NATIONAL DAM SAFETY PROGRAM, BRUSHY CREEK TAILINGS DAM (MO 3095-ETC(U)

PHASE I INSPECTION REPORT
NATIONAL DAM SAFETY PROGRAM
BRUSHY CREEK TAILINGS DAM - MO. 30951

Name of Dam:	Brushy Creek Tailings Dam
State Located:	Missouri
County Located:	Reynolds County (Mark Twain National Forest)
Stream:	Schoolhouse Branch of Bill's Creek
Date of Inspection:	15 November 1978

Embankment cross-section showing range of piezometer readings.

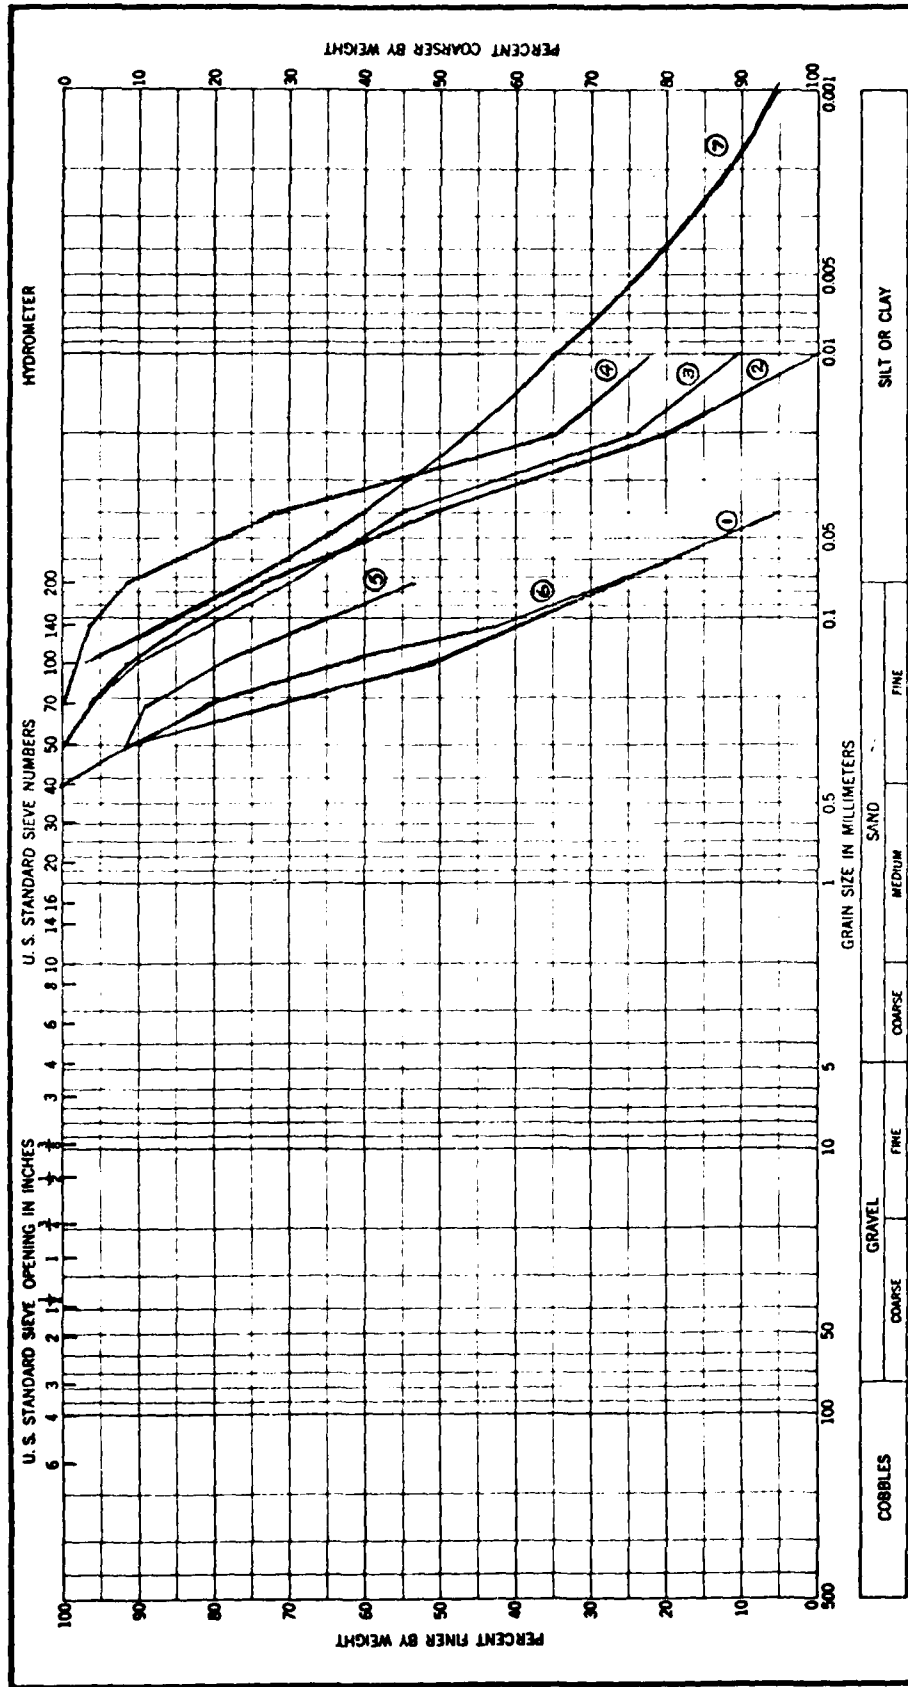
A number of open-system piezometers have been installed and regularly monitored in the embankment. A summary of the observed piezometric readings is shown on Plate B-3.

The fine granular materials utilized in constructing the majority of the embankment should be highly susceptible to internal erosion. Plate B-4 shows the range of gradations determined from samples obtained from the cyclone underflow (sand-sized materials used in the embankment). Unsegregated tailings and cyclone overflow (fines) are also shown on Plate B-4. The rockfill drains, consisting of rock sizes greater than 6 inches in diameter, do not conform to acceptable standards for graded filters in fine sands. The potential for internal erosion cannot, therefore, be excluded.

PHOTO 3: Downstream slope looking toward southeast
(left) abutment.

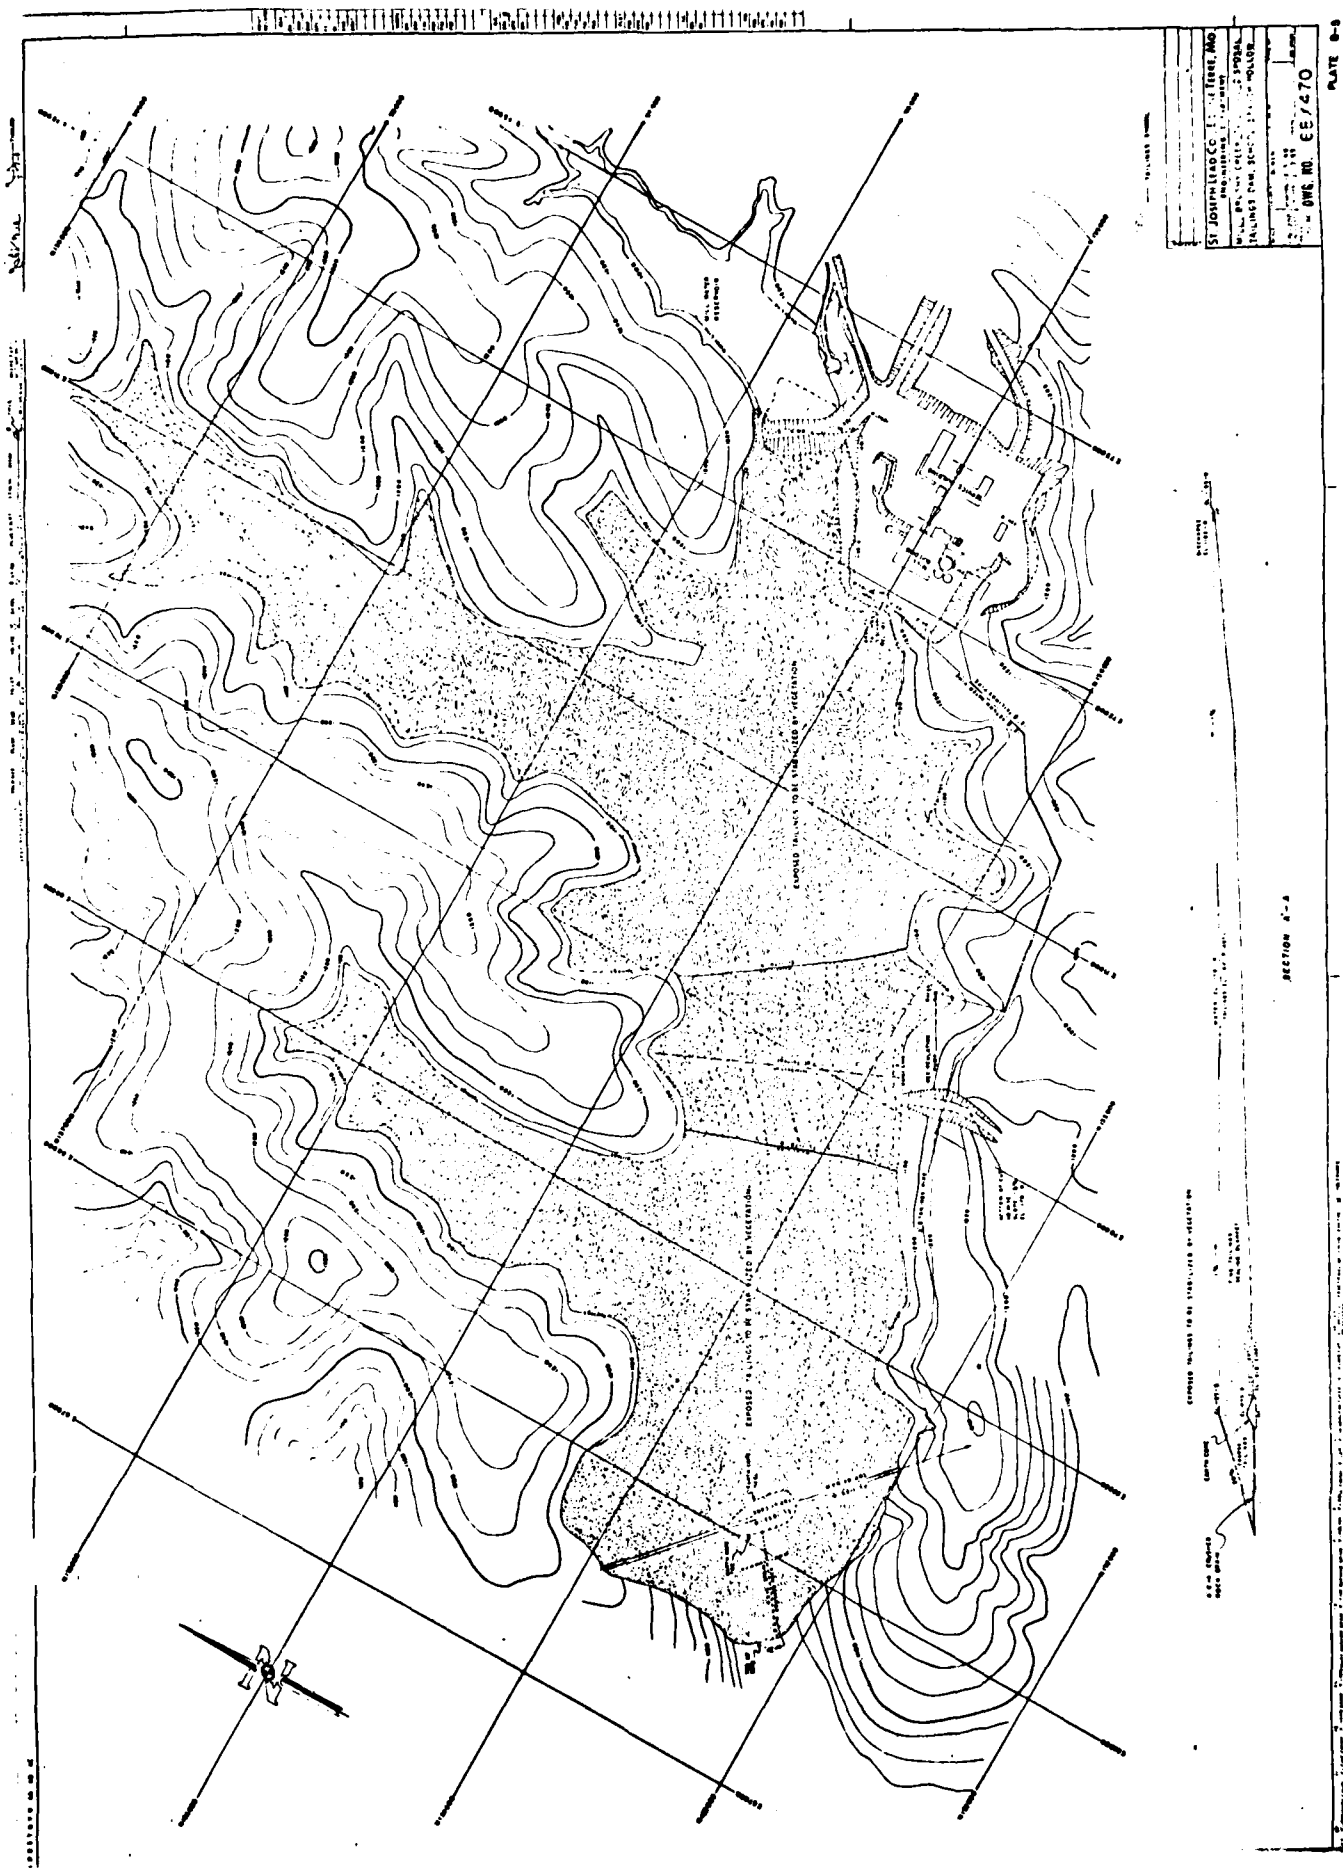
The downstream slope of the dam is typically 1 vertical on 3.5 horizontal. It has few discontinuities and little surface erosion. See Photos 2 and 3. There is no evidence of movement nor is there any vegetation or slope protection.

Where the downstream slope interfaces with the southeast abutment there is an erosion channel. This surface erosion is entirely in the sand tailings material and ranges up to 3 feet deep with a width of 4 to 5 feet. A diversion ditch has been provided in natural overburden materials on the abutment in order to alleviate this problem by preventing abutment runoff from reaching the embankment slope. Approximately one third of the dam height from the toe, nearly 25 trees, 4 to 14 inches in diameter, were not cleared prior to tailings disposal. These trees are partially covered by tailings on the southeast abutment interface. See Photo 3. A similar situation exists at approximately two-thirds of the dam height from the toe.

f. Maintenance on a regular basis is recommended to repair surface erosion features, especially those at the abutment contacts.
